RE: **PROJECT NO. SW-2020-01-05-TO1 108TH STREET RCB
EXTENSION**

ADDENDUM NO. 1

Project: 108th Street RCB Extension

Addendum No. 01

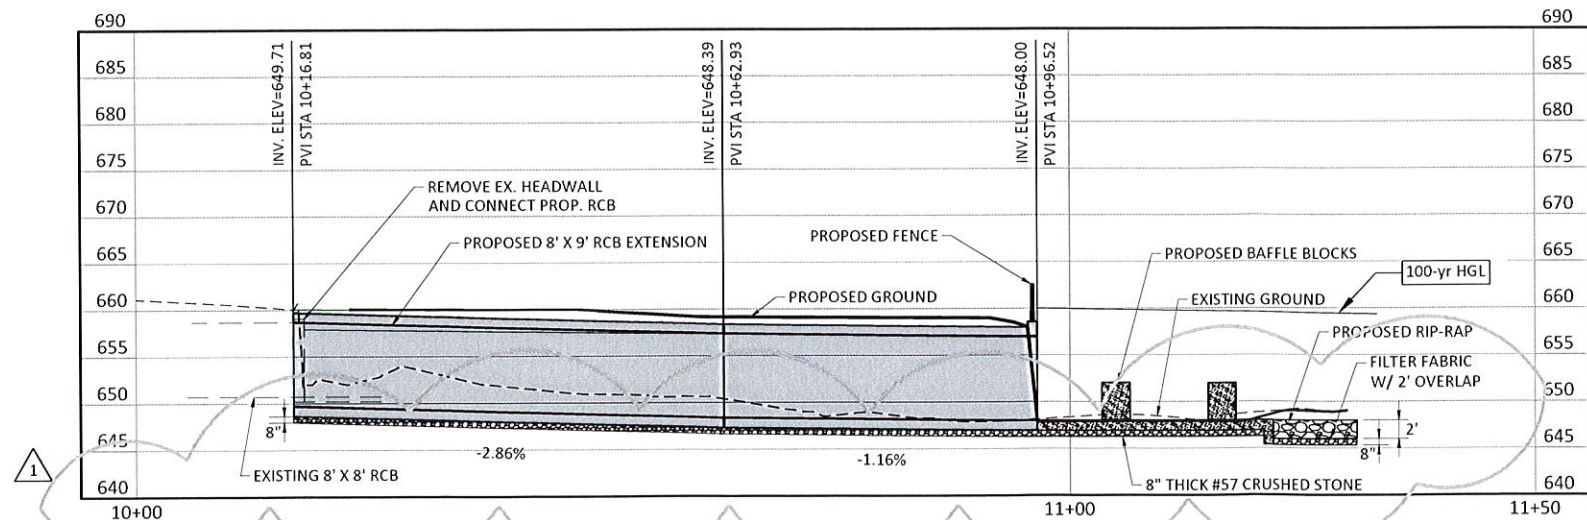
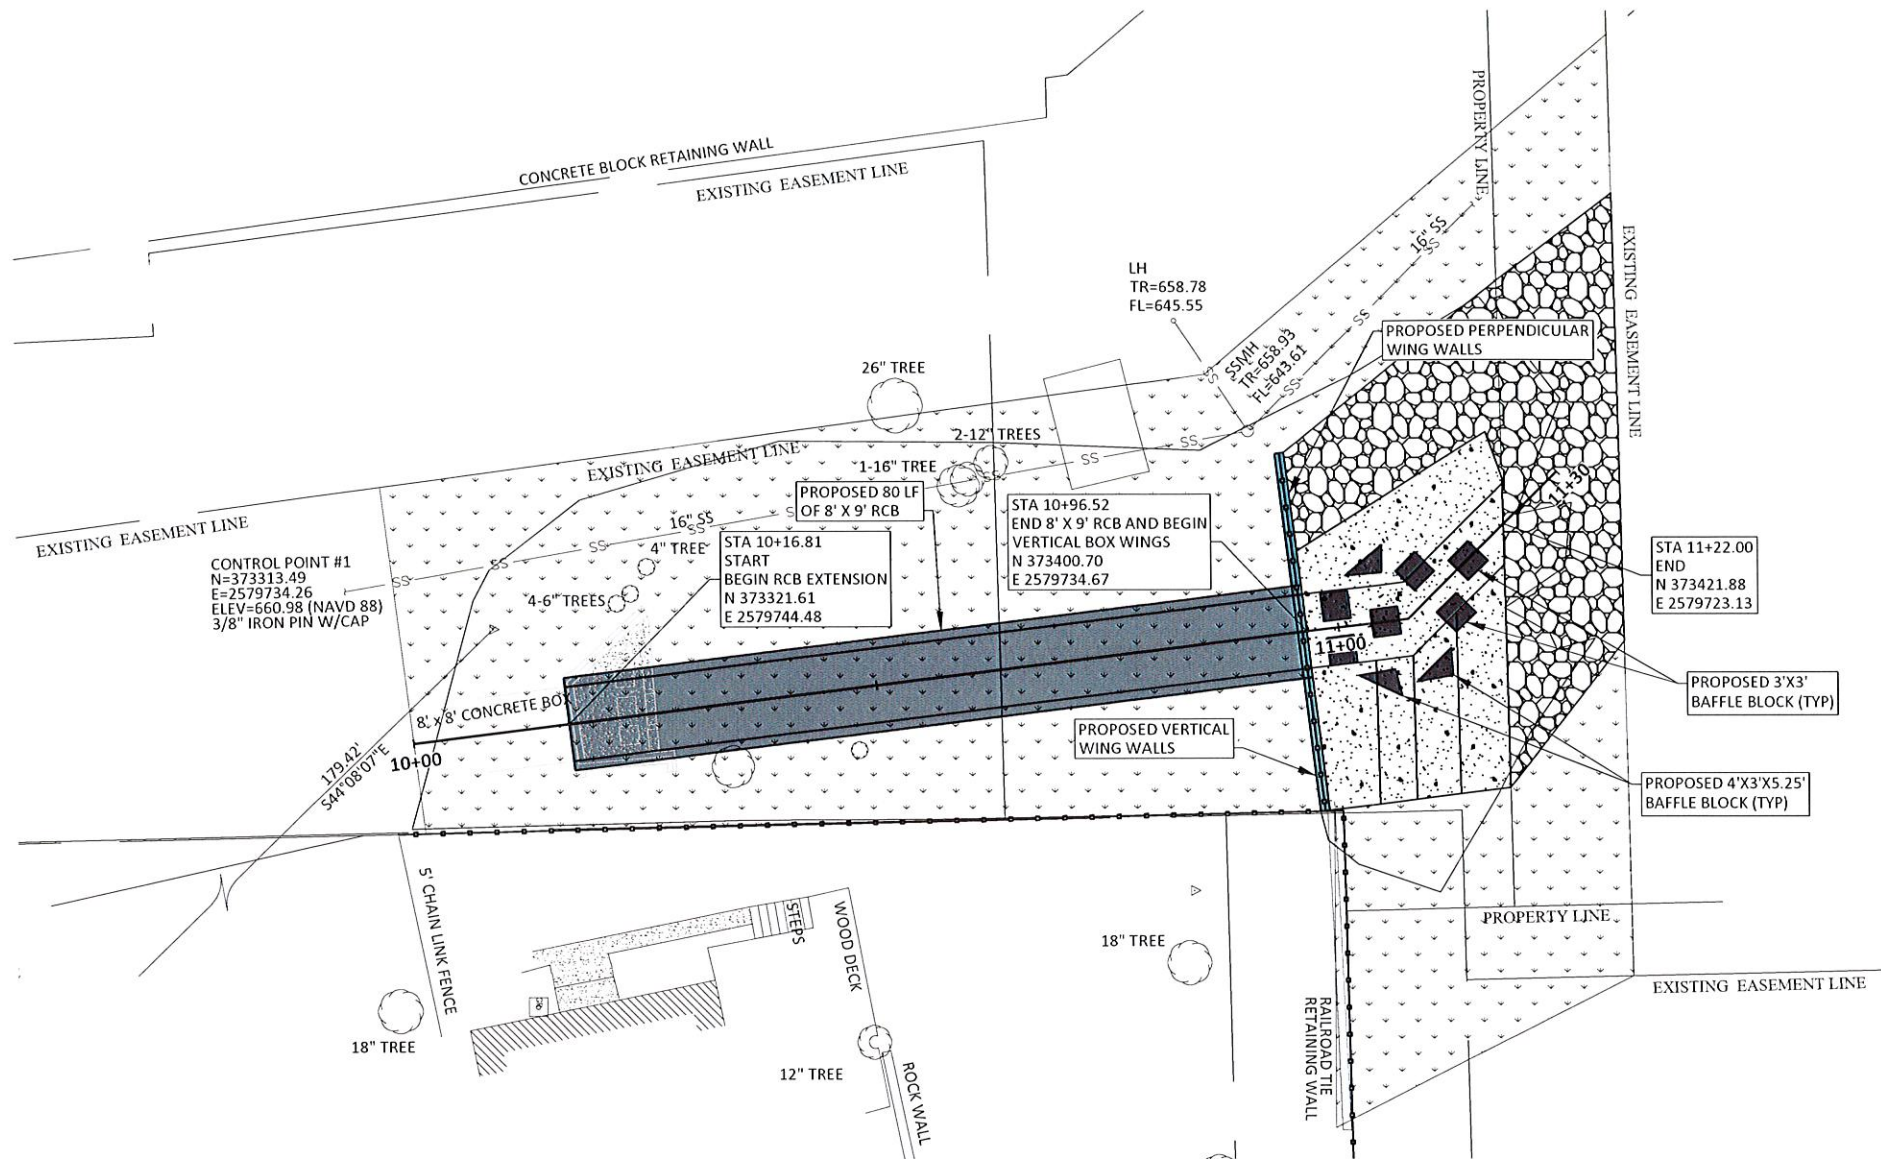
1. There is no Separator Fabric for this project, filter fabric will be used as a substitute. See sheets 2, 6, 12, and 14.
2. Class AA Concrete is now Class A Concrete. See sheets 2 and 14.
3. Class A Aggregate has been changed to No. 57 Aggregate. See sheets 2, 6, 12, 13, and 14.
4. Delete the existing bid proposal form in its entirety and replace with the revised Bid Proposal located at the following link:
<https://www.cityoftulsa.org/government/departments/engineering-services/construction-bids/SW-2020-01-0-TO1>

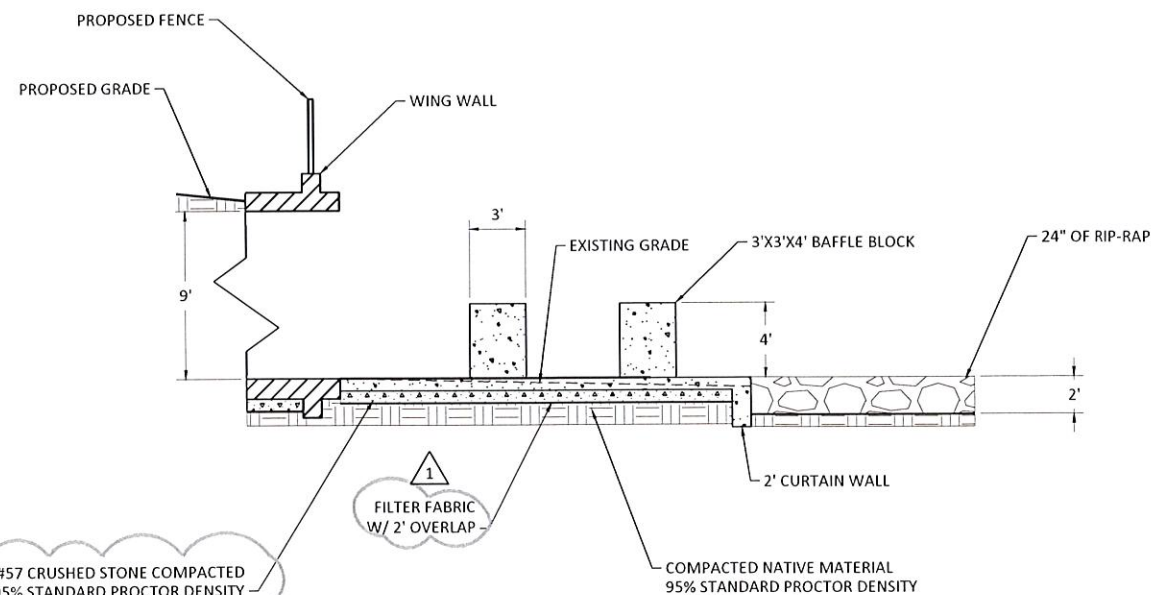
1. **Question:** Will you please provide the geotechnical data for this project?
Clarification: No geotechnical data is available for this project.
2. **Question:** Sheet 6 calls for 18 inches of aggregate base under the RCB and apron. However, plan sheets 12 and 14 call for 8 inches. Please advise as to which is the correct depth that needs to be utilized.
Clarification: 8" is the correct thickness, and the 18" is a typo.

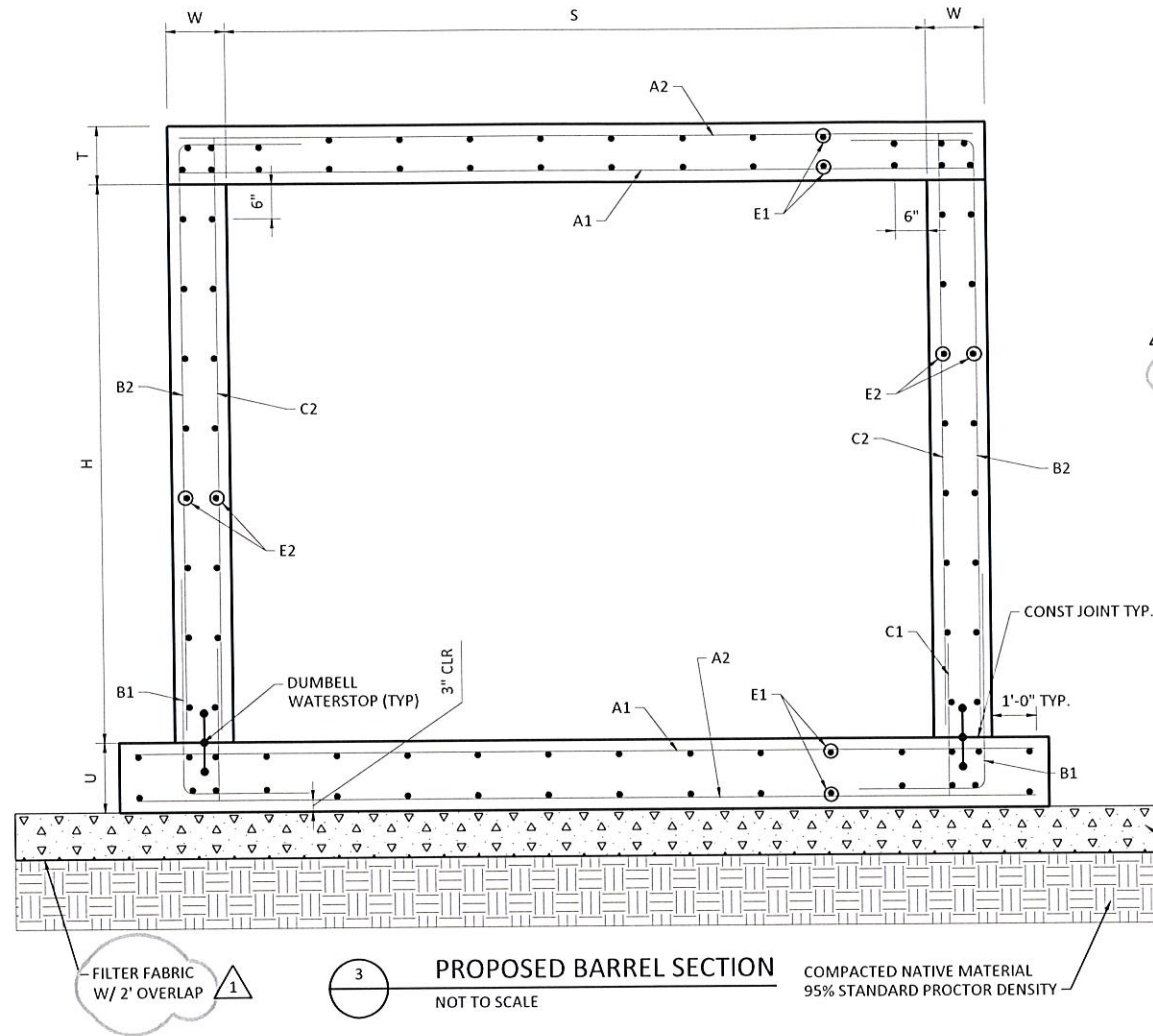
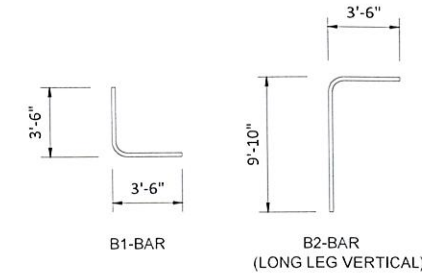
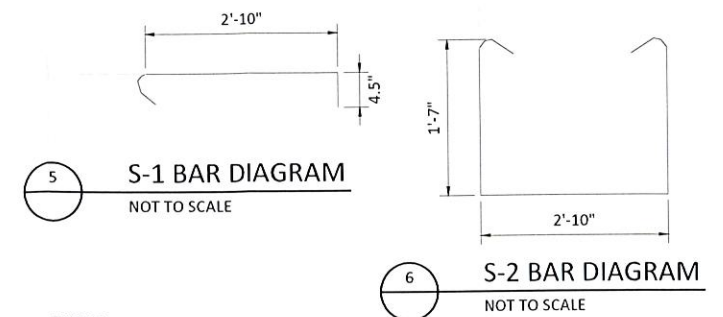
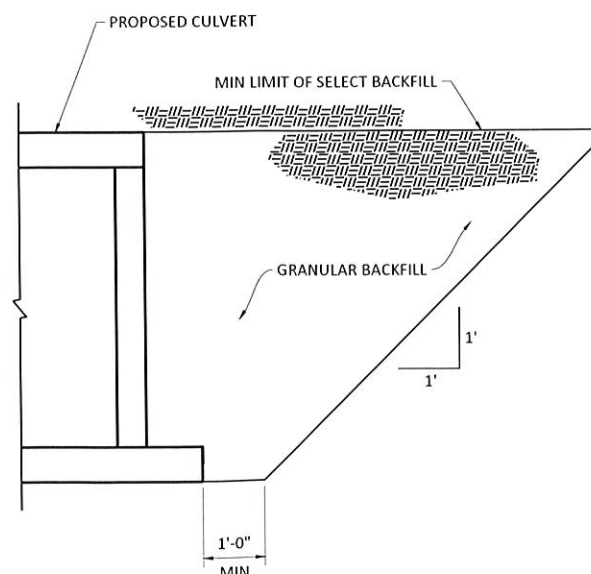
3. **Question:** On sheet 14 the design data for the RCB structure calls for Class AA, however, the pay items are calling for Class A concrete. Please advise as to which class of concrete is the correct Class of concrete to use. If Class AA is the correct mix design, please correct the proposal to reflect this.

4. **Question:** What/where is the intended usage of Filter Fabric (Trench) supposed to be? It looks as if separator fabric is to be utilized under the RCB, wing walls, apron, and toe walls.

Clarification: The concrete used shall be Type A, not Type AA.

Clarification: Correct, filter fabric shall be placed underneath the RCB, wing walls, apron, and toe walls.

① 8" THICK #57 CRUSHED STONE COMPACTED TO 95% STANDARD PROCTOR DENSITY

- DESIGNED IN ACCORDANCE WITH 2017 AASHTO LRFD BRIDGE DESIGN SPECIFICATIONS.
- DESIGNED FOR HL-93 LOADING AND ODOT OVERLOAD TRUCK.
- MATERIALS:
CONCRETE (CLASS A) $f_c = 4$ KSI
REINFORCING STEEL $f_y = 60$ KSI
